Technical BULLETIN

ALL 2008 PZ50GTX/MTX MODELS

Insufficient Heat Output from Grip Warmers

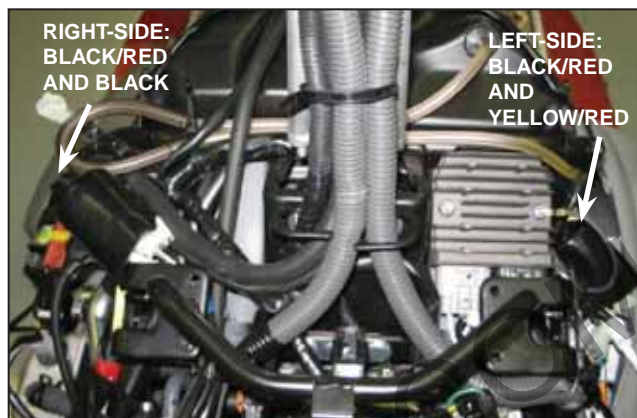
1. Remove the windshield.
2. Remove the headlight cover. Remove the 3 bolts, on each side of the unit, to remove the left and right side panels.
3. Remove the headlight assembly and the fuel tank cover.
4. Locate the grip warmer wire harness connectors, on both sides of the unit, inside the rubber boots (see adjacent photo).

NOTE: The left side main harness connector wire colors are Black/Red and Yellow/Red. The right side are Black/Red and Black

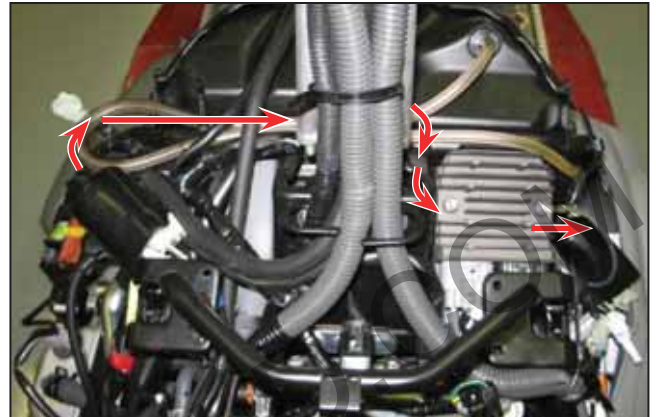
8. To route the new sub-harness, loosen the two plastic wire clamps that secure the fuel tank vent hoses to the steering gate (see adjacent photo). Install the sub-harness along the steering gate and behind the steering column. Retighten the plastic wire clamps as shown.

9. Position the sub-harness inside the wire holder following the main harness routing (see adjacent photo). The sub-harness should be routed behind the regulator/rectifier.

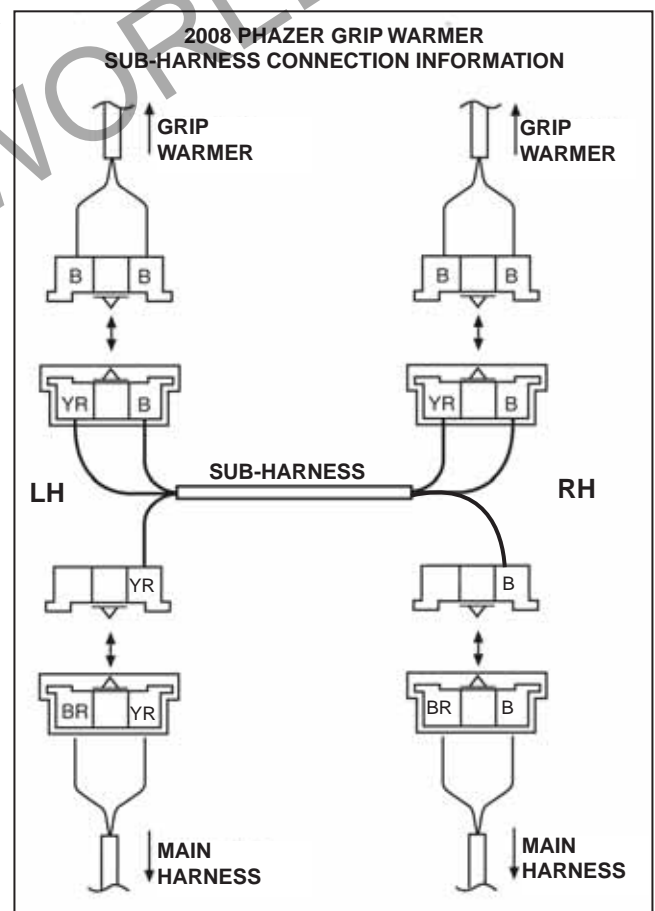
10. On the left side of the unit, insert the sub-harness through the back of the rubber boot and then connect it to the main harness and grip warmer as shown in adjacent wiring illustration.
